ADDENDUM NO. ONE (1)

Owner:	Pearl River Valley Water Supply District
Project:	Shoreline Protection Rehabilitation, Phase 2

**PEARL RIVER VALLEY WATER SUPPLY DISTRICT
 SHORELINE PROTECTION
 REHABILITATION, PHASE 2
 RANKIN COUNTY, MISSISSIPPI**

SHEET #
1

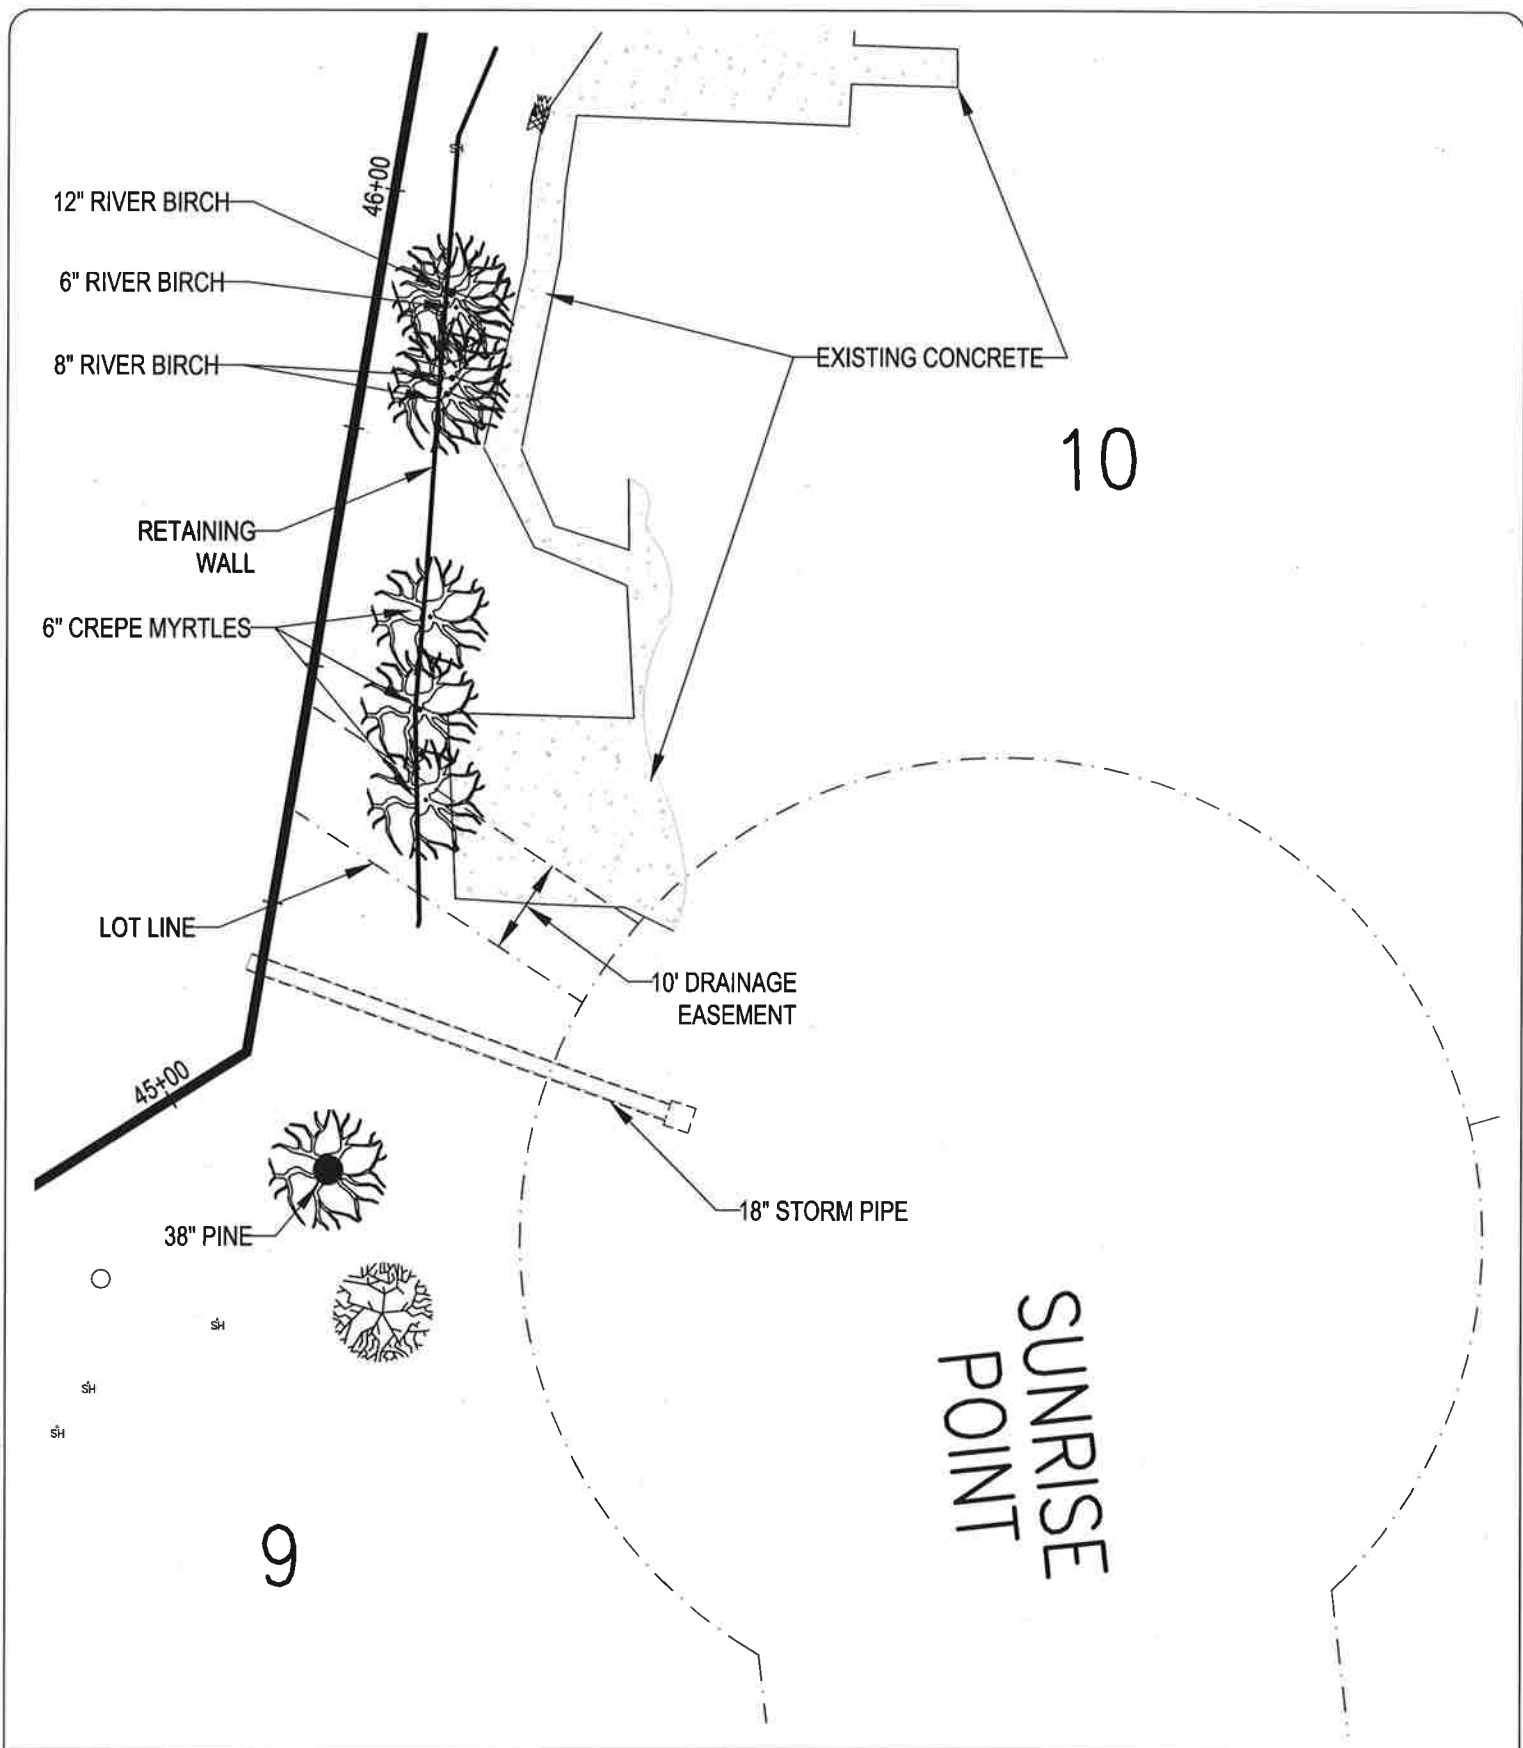
1. Sheet C1.03: Add labels to Sheet C1.03 to indicate the lot line separating Lots 9 and 10 and the drainage easement on Lot 10 (see attached drawing).
